147 Major St — HVAC clash mark-up

HVAC Designs LO# 113963 (HVA 26 167838) vs permit 26 167838 BLD 00 · PalmView BIM review · Oct 22, 2026

Two systems: F-1 basement (basement + main floor from below) · F-2 2nd-floor mech room (2nd + 3rd floors from the 3rd-floor joist space).

Sheet Title
BASEMENT HEATING LAYOUT

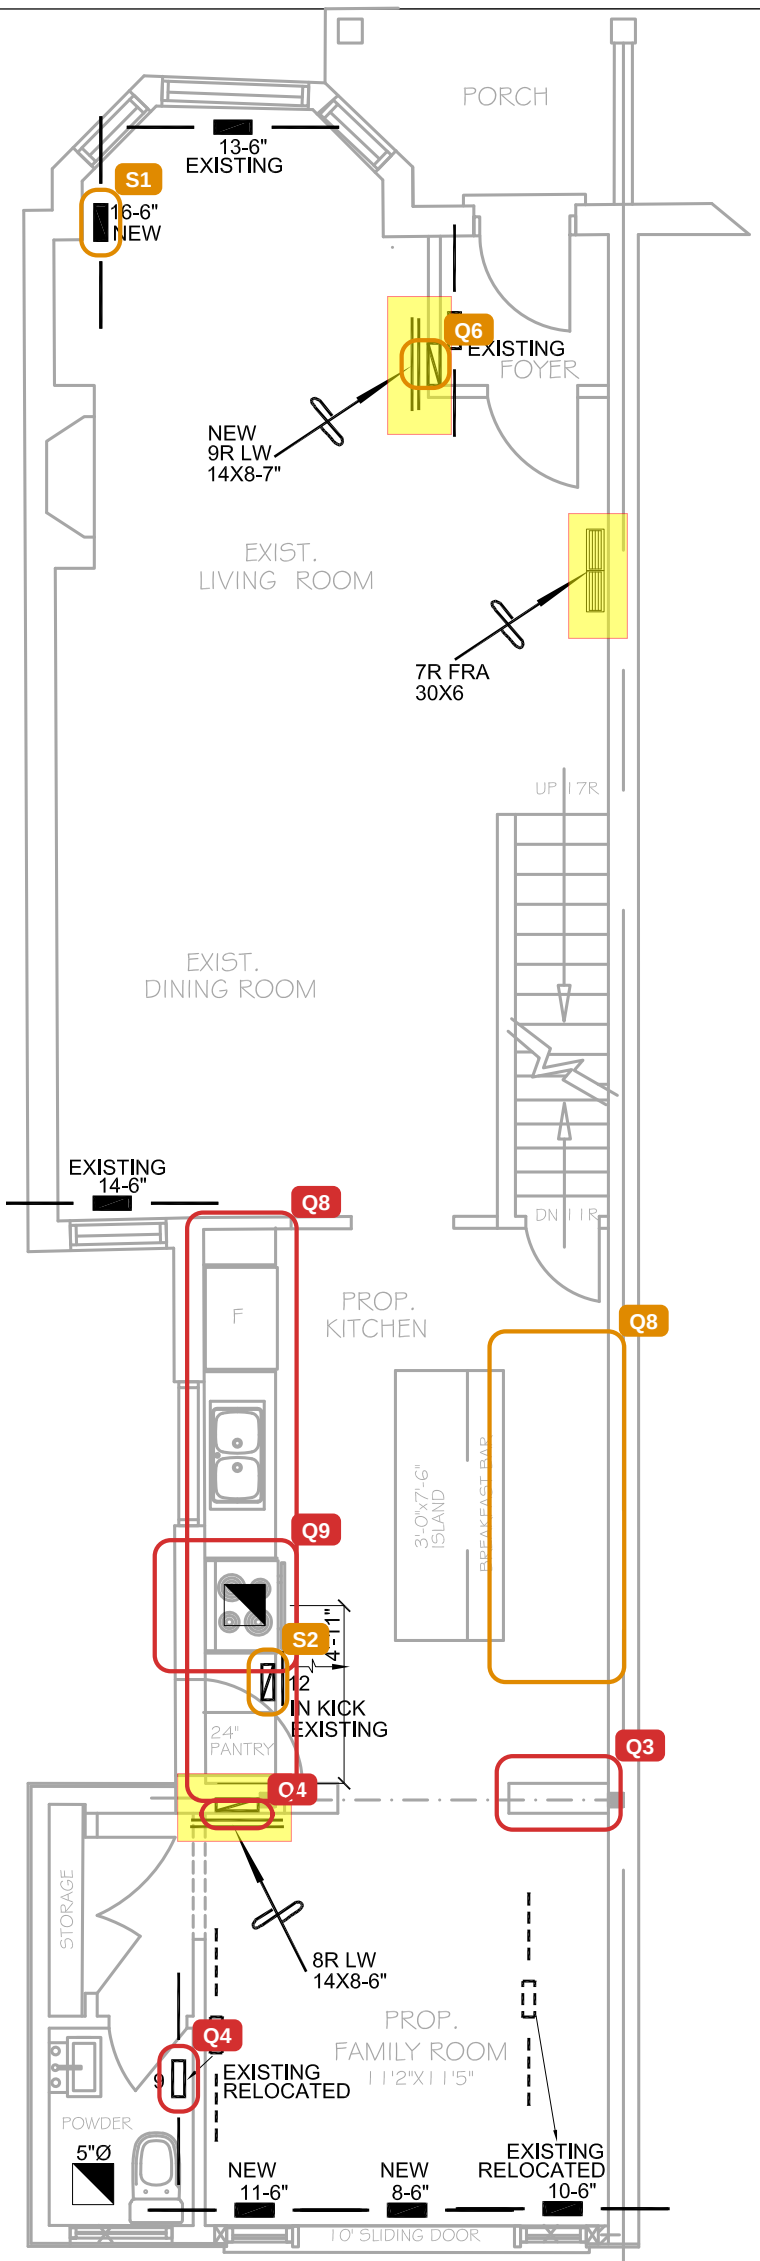
Core three holes in the brick, or route all rear branches through the existing 30" opening. Owner: HVAC sub. Status: OPEN.

Both stacks land on top of existing masonry (powder E wall, pantry/storage double wall). Relocate. Owner: HVAC Designs. Status: OPEN.

All stick out 3–4" past the studs. 3-1/4x14 stacks, 2x6 walls, or chases. Owner: HVAC sub / framer. Status: OPEN.

F-1 not tagged existing and sits where the permit shows the existing H.E. furnace. Takeoff runs over the tank vent. Owner: PalmView. Status: OPEN.

Q3 Rear branches 8, 10, 23 through the old rear foundation

Q4 Supply 9 and return 8R sit on old foundation walls

Q6 7" return stacks in 2x4 walls (1R–6R, 9R) and 6" supply stacks

Q10 F-1 new or existing; hot water tank vs plenum

S3 Trunk E ends ½" off the old rear wall

Sheet Title
FIRST FLOOR HEATING LAYOUT

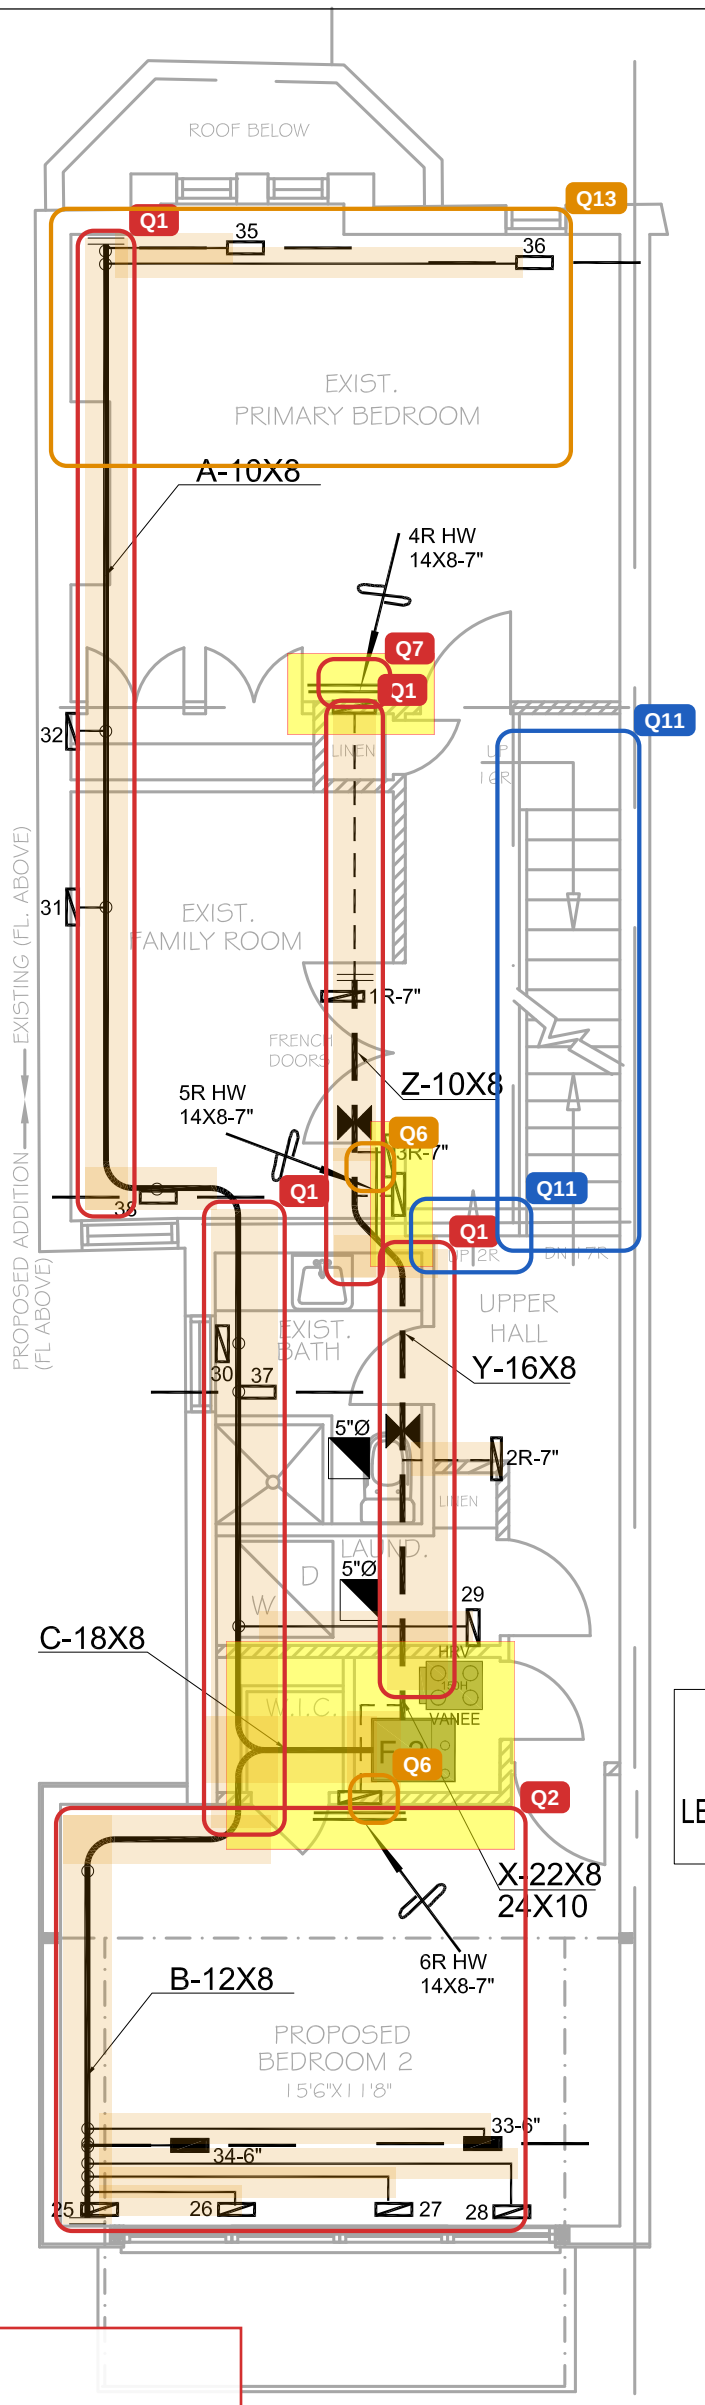
Permit shows a 30" range and 34" fridge; Miele range and fridge are 36". Cabinet set 186.5" vs 184.6" wall. Aisle to the stair is 34.9". Owner: Cabinet shop / PalmView. Status: OPEN.

Elica Trento insert on the south wing wall under the 2nd-floor overhang. No duct or termination drawn. Owner: HVAC Designs. Status: OPEN.

- Q3 Rear branches 8, 10, 23 through the old rear foundation
- Q4 Supply 9 and return 8R sit on old foundation walls
- Q6 7" return stacks in 2x4 walls (1R–6R, 9R) and 6" supply stacks
- Q8 Kitchen sizes: range, fridge, run length and aisle
- Q9 Kitchen hood exhaust not designed
- S1 Supply 16 boot tight to the bay corner
- S2 Supply 12 kick register under the pantry

Sheet Title
SECOND FLOOR HEATING LAYOUT

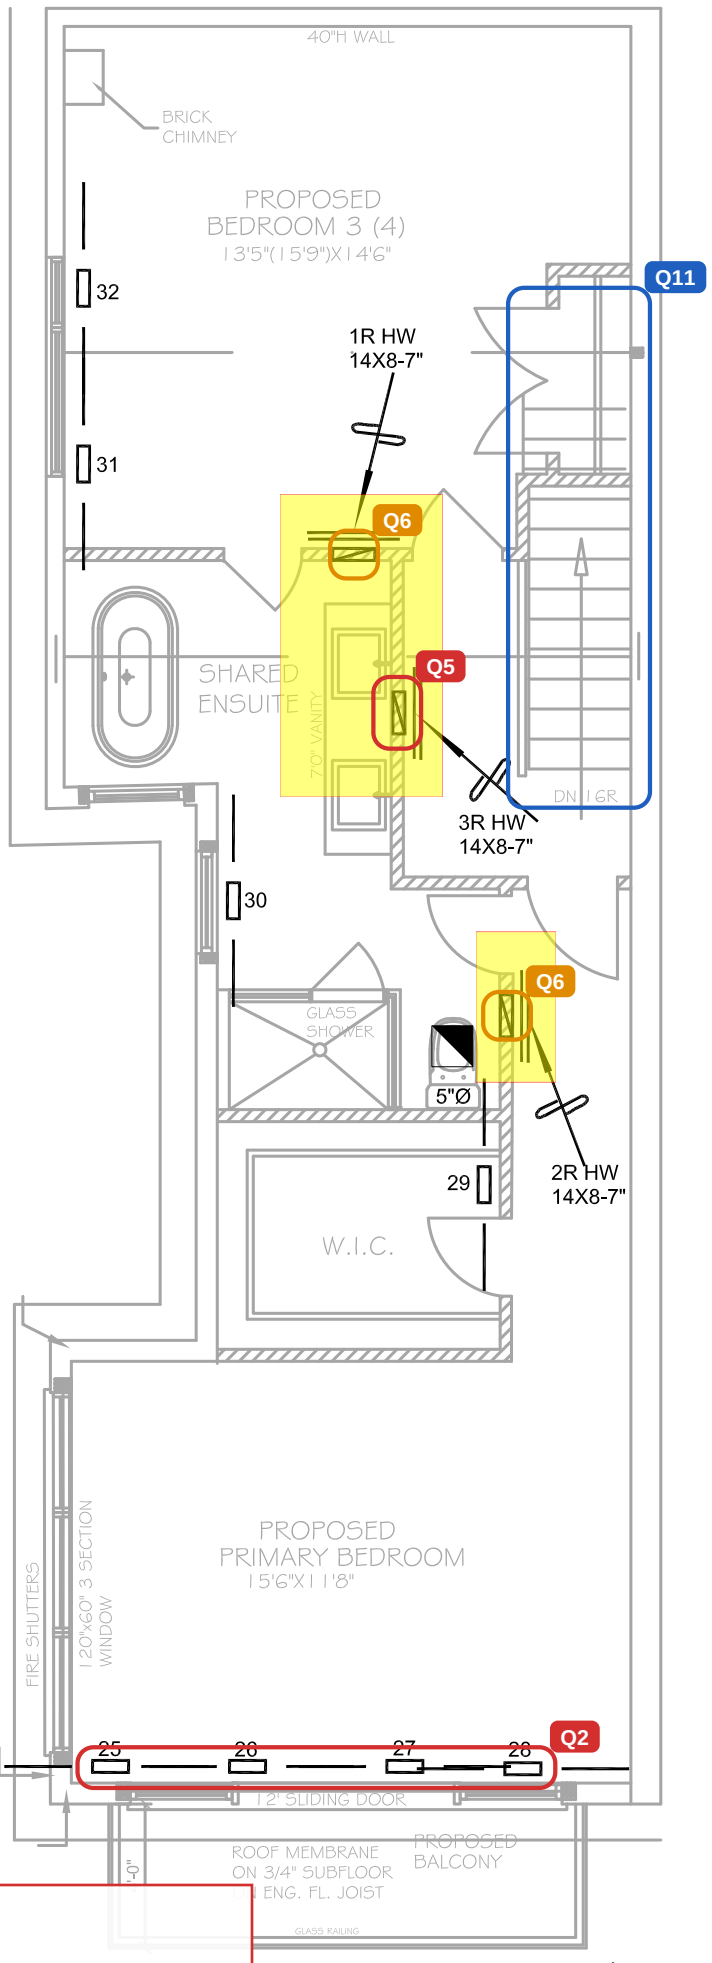
Rear (lower) level, 10'-4½" ceiling: drop the hall / bath / laundry / W.I.C. / bedroom 2 ceilings flat to ~9'-6" to hide C, B, Y, 6R and branches 25-28, 33/34 (or box them at 9'-8"). Front (upper) level, 9'-0½" ceiling: trunk A along the south wall and return Z in the family room need 14" bulkheads at 8'-4", or a reroute. Owner: PalmView / client. Status: RESOLVED.

Confirm the cantilever TJIs over bedroom 2 run front-to-back (balcony). Trunk B sits on the south LVL1; 5 branches cross 26 cantilever joists. Owner: Kott / Rona + engineer. Status: SITE.

Grille is on the closet wall right under LVL5; the stack cannot pass the beam. Owner: HVAC Designs / engineer. Status: RESOLVED.

Plans A8/A9: new stair stacked over the existing one, rising front-to-rear. Section A-A draws it rising rear-to-front. Step: section A-A framing shows 16" (2R at 8"); the rear and south elevations show 1'-9" (10'-11" vs 9'-2"). Model uses 16". Owner: PalmView / designer. Status: OPEN.

Trunk A (first 6.7 ft) and branches 35/36 are under the existing front roof. If that space is outside the insulation, ducts need R-12 + Class A sealing (permit note). Owner: PalmView. Status: OPEN.

Q1 2nd-floor ceilings for the F-2 trunks

Q2 Bedroom 2 ceiling: joist direction and trunk B on LVL1

Q6 7" return stacks in 2x4 walls (1R–6R, 9R) and 6" supply stacks

Q7 Return 4R stack vs the LVL5 flush beam

Q11 Stair direction 2nd → 3rd, and the size of the 2nd-floor step

Q13 Front roof space over the primary bedroom

Hung under the joists, three runs moved off wall top plates: trunk C 2" east (was 1.4" into the notch wall), return Y 5" east (was over the bath east wall), 6R run and stack 5" east (was over the W.I.C./mech wall). Still to place on site: the C-to-A tie (10x8 at the step line) lands between the family-room rear wall and the bath north wall, which are only 7.8" apart - box it on the family-room side.

Front (existing house, y < 28 ft) is the upper level at 113.85; the kitchen-wing / addition part steps down. Measured 16" from the section A-A framing; UP 2R at the stair landing; flush LVL5 on the step line. Ground stair 17R lands on the lower level. Model updated.

The south wall jogs in to x 4.2-5.0 ft from y 28 to 44 ft at every level, basement to third floor. Removed the 2nd/3rd-floor cantilever over the side yard; bath and ensuite windows moved onto the notch wall. HVAC Designs backgrounds already show it correctly.
